**AIP SUPPLEMENT
(SUP)****AIRAC****H91/25**

RICHMOND (NSW) AERODROME (YSRI) NEW DEPARTURE AND APPROACH PROCEDURES

- 1.1 This AIP SUP cancels and replaces SUP H81/25 with an updated Appendix 2.
- 1.2 This AIP SUP introduces new Departure and Approach Procedures (DAP) for Richmond (NSW) Aerodrome (YSRI).

**APPENDIX 1
TO SUP H91/25**
**RNP RWY 10
RICHMOND, NSW (YSRI)**

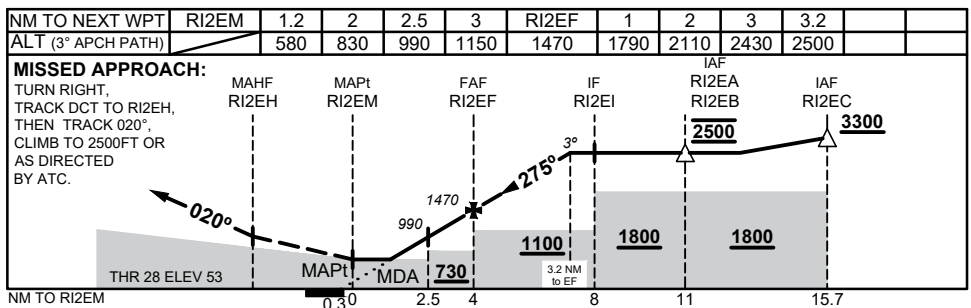
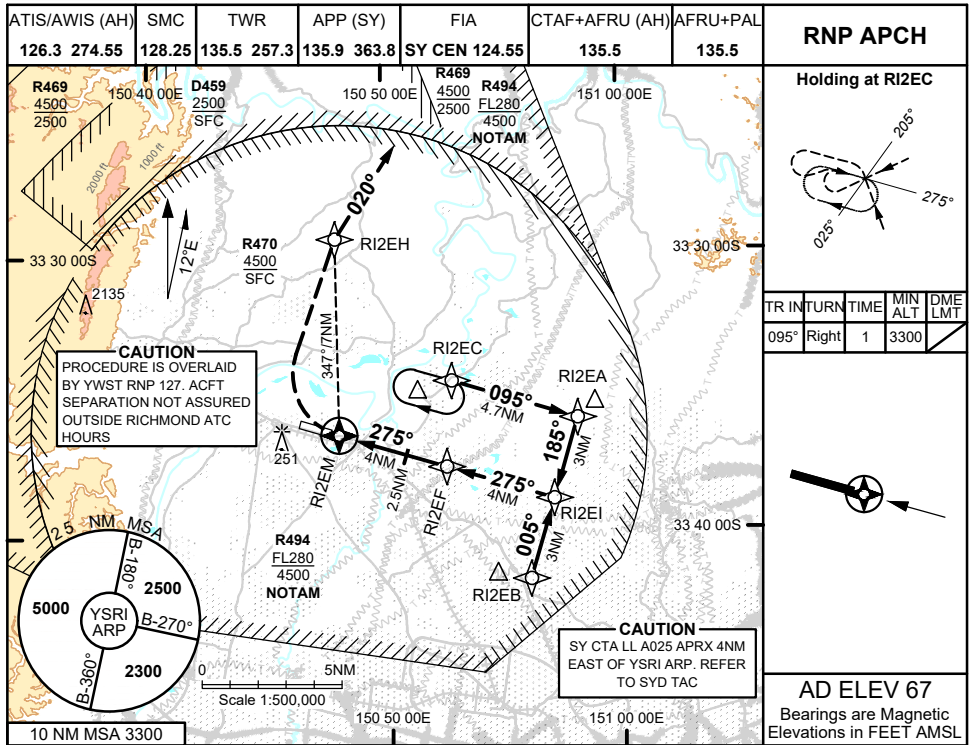
Changes: NEW PROCEDURE
